UNITED STATES
DEPARTMENT OF THE INTERIOR
BUREAU OF LAND MANAGEMENTFORM APPROVED
OMB NO. 1004-0137
Expires: January 31, 2018**SUNDRY NOTICES AND REPORTS ON WELLS**
*Do not use this form for proposals to drill or to re-enter an abandoned well. Use form 3160-3 (APD) for such proposals.*5. Lease Serial No.
NMNM110836

FEARLESS 23 FED COM 505H

EOG Resources, Inc. respectfully requests to amend the cementing program & casing program.

**Lea County, New Mexico
Revised Wellbore 5/23/2019**

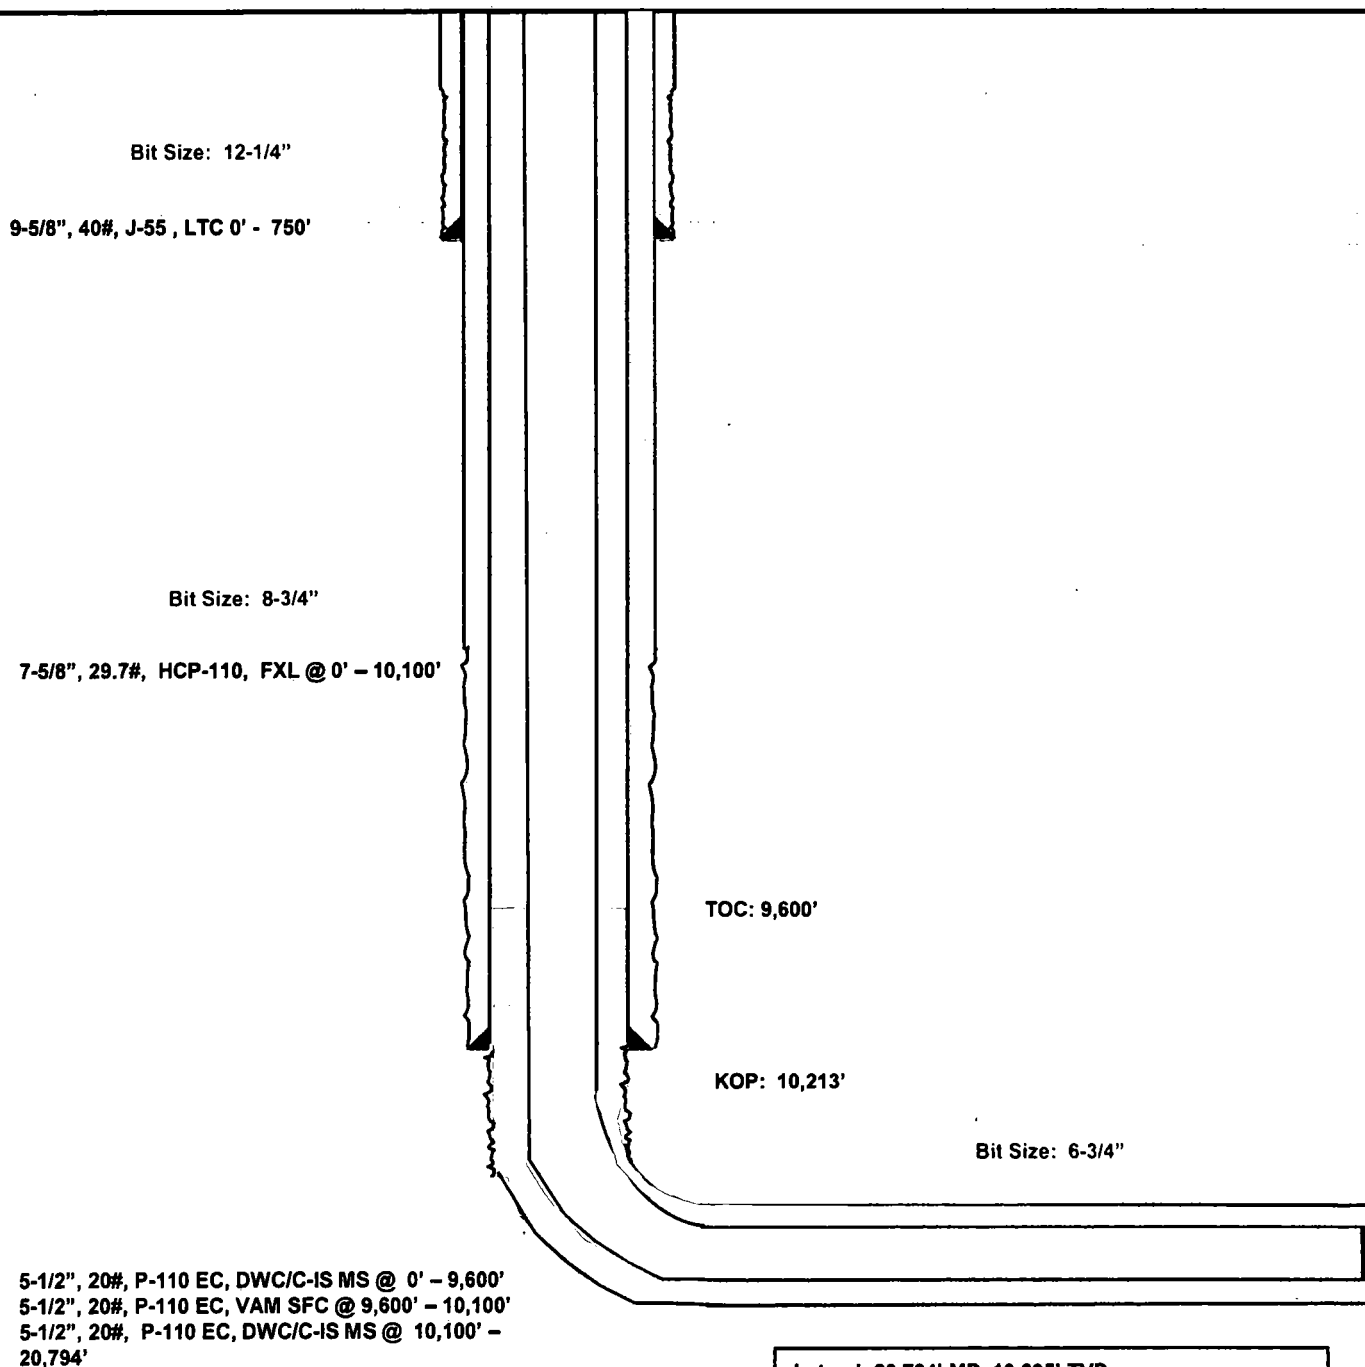
Hole Size	Interval	Csg OD	Weight	Grade	Conn	DF _{min} Collapse	DF _{min} Burst	DF _{min} Tension
12.25"	0 – 750'	9.625"	40#	J-55	STC	1.125	1.25	1.60
8.75"	0 – 10,100'	7.625"	29.7#	HCP-110	FXL	1.125	1.25	1.60
6.75"	0' – 9,600'	5.5"	20#	P-110 EC	DWC/C-IS MS	1.125	1.25	1.60
6.75"	9,600' – 10,100'	5.5"	20#	P-110 EC	VAM SFC	1.125	1.25	1.60
6.75"	10,100' – 20,794'	5.5"	20#	P-110 EC	DWC/C-IS MS	1.125	1.25	1.60

Variance is requested to waive the centralizer requirements for the 7-5/8" FJ casing in the 8-3/4" hole size. An expansion additive will be utilized, in the cement slurry, for the entire length of the 8-3/4" hole interval to maximize cement bond and zonal isolation.

Variance is also requested to waive any centralizer requirements for the 5-1/2" FJ casing in the 6-3/4" hole size. An expansion additive will be utilized, in the cement slurry, for the entire length of the 6-3/4" hole interval to maximize cement bond and zonal isolation.

Variance is also requested to waive the annular clearance requirements for the 5-1/2" casing by 7-5/8" casing annulus to the proposed top of cement.

EOG requests permission to allow deviation from the 0.422" annulus clearance requirement from Onshore Order #2 under the following conditions:

- Annular clearance to meet or exceed 0.422" between intermediate casing ID and production casing coupling only on the first 500' overlap between both casing strings.
- Annular clearance less than 0.422" is acceptable for the curve and lateral portions of the production open hole section.

EOG requests to pump a two stage cement job on the 7-5/8" intermediate casing string with the first stage being pumped conventionally with the calculated top of cement at the Brushy Canyon and the second stage performed as a bradenhead squeeze with planned cement from the Brushy Canyon to surface. If necessary, a top out consisting of 1,000 sacks of Class C cement + 3% Salt + 1% PreMag-M + 6% Bentonite Gel (2.30 yld, 12.91 ppg) will be executed as a contingency. The final cement top will be verified by Echo-meter.

1. The 9-5/8 inch surface casing shall be set at approximately **875** feet (a minimum of 25 feet (Lea County) into the Rustler Anhydrite and above the salt) and cemented to the surface.

2. The minimum required fill of cement behind the 7-5/8 inch intermediate casing is:

Operator has proposed to cement in two stages by conventionally cementing the first stage and performing a bradenhead squeeze on the second stage.

- Operator will cement to **7,000** feet with intent to reach Top of Brushy Canyon.

- Operator will perform bradenhead squeeze with cement to surface.

Operator has proposed to pump down 9-5/8" X 7-5/8" annulus. Operator must run Echo-meter to verify fluid top and the volume of displacement fluid above the cement slurry in the annulus.

3. The minimum required fill of cement behind the 5-1/2 inch production casing is:
 - Cement should tie-back at least **200 feet** into previous casing string. Operator shall provide method of verification.
